State of New Mexico
Energy, Minerals and Natural Resources

OIL CONSERVATION DIVISION
1220 South St. Francis Dr.
Santa Fe, NM 87505

WELL API NO. 30-025-10314
5. Indicate Type of Lease STATE <input checked="" type="checkbox"/> FEE <input type="checkbox"/>
6. State Oil & Gas Lease No. 647
7. Lease Name or Unit Agreement Name State 647 AC 721
8. Well Number 201
9. OGRID Number 370080
10. Pool name or Wildcat: Artesia; Queen-Grayburg-San Andres

Breithurn Operating LP respectfully requests approval to plug and abandon wellbore as follows:

Proposed Wellbore Configuration

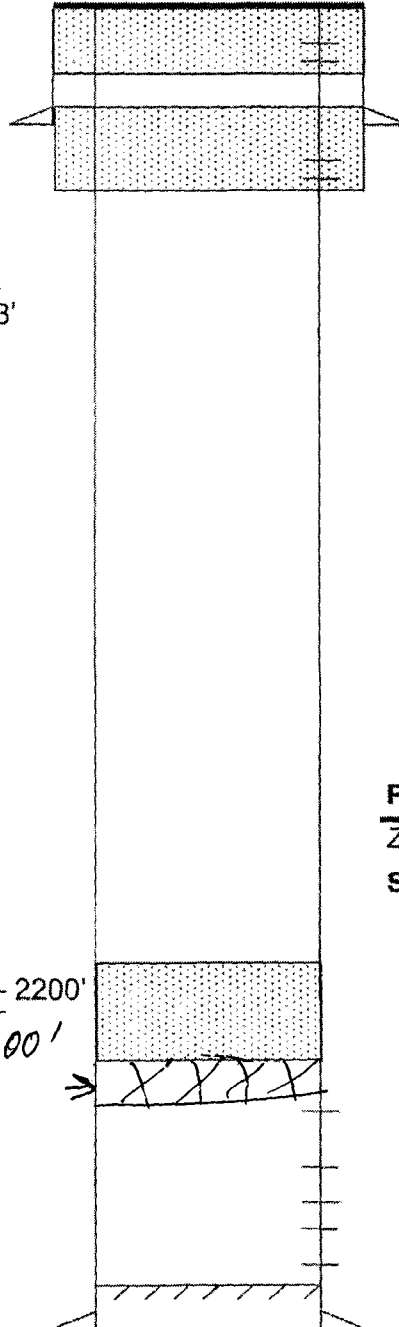
Set CIP @ 2200' -
MIRU PU, POOH with rods and tubing. Load hole with plug mud. Set 25 sx cement plug ~~2500'~~ ^{2700'} to 2200'. WOC. Tag. Perf 4 1/2" casing @ 523'. Set 30 sx cement in/out plug 523' to 423' to isolate surface casing shoe. Perf 4 1/2" casing @ 60'. Circulate cement to surface. RDMO PU. Weld on 1/2" steel plate and erect well marker.

WOB & TAC
 25 sk cmt plug from ~~2000'~~ 2700' - 2200'
 SET CIBP @ 2700'
